Revision 1	ALERT SERVICE BULLETIN No. 39	DOA No. EASA.21J.020
------------	--	-------------------------

Subject: Replacement of the Propeller Guide Rod

Silver Shiny stainless steel propeller guide rod A-1856-1, A-1870-1, A-1931-1 (see red mark below)

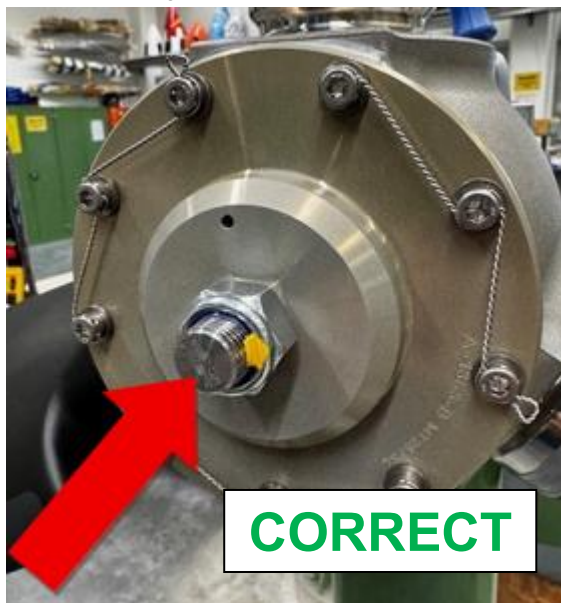
Not Affected

All mentioned propeller models, operated as ground adjustable units must have the stainless-steel guide rod (silver shiny) A-1856-1 (MTV-33 series) or A-1870-1 (MTV-34 series) or A-1931-1 (MTV-36 series) installed.

The anodized colored propeller guide rod A-1856-(), A-1870-(), A-1931-() (see red mark below)

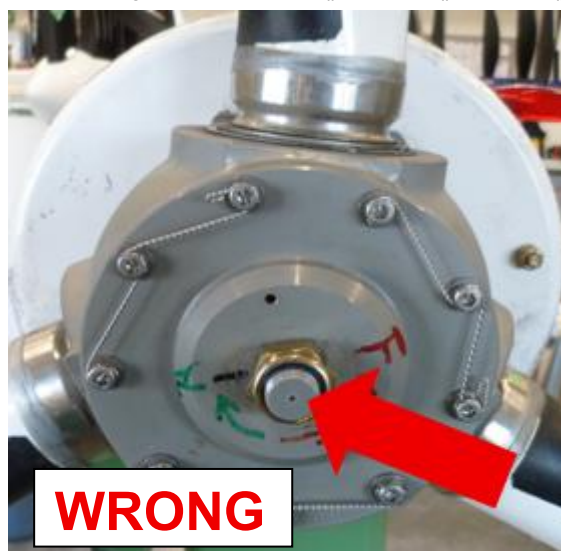
The originally installed propeller guide rod which is made out of aluminum (anodized colored) can be damaged when the propeller is used as a ground adjustable system.

Adjustments on the low pitch stop nut, can damage the aluminum propeller guide rod in the threaded area, when torqued with a high force to the stop.

Affected, if operated
as ground adjustable
propeller

Action: **THE ANODIZED COLORED GUIDE ROD MUST BE REPLACED WITHIN 6 MONTHS OR 100 FLYING HOURS, AFTER RELEASE OF THIS SERVICE BULLETIN.**
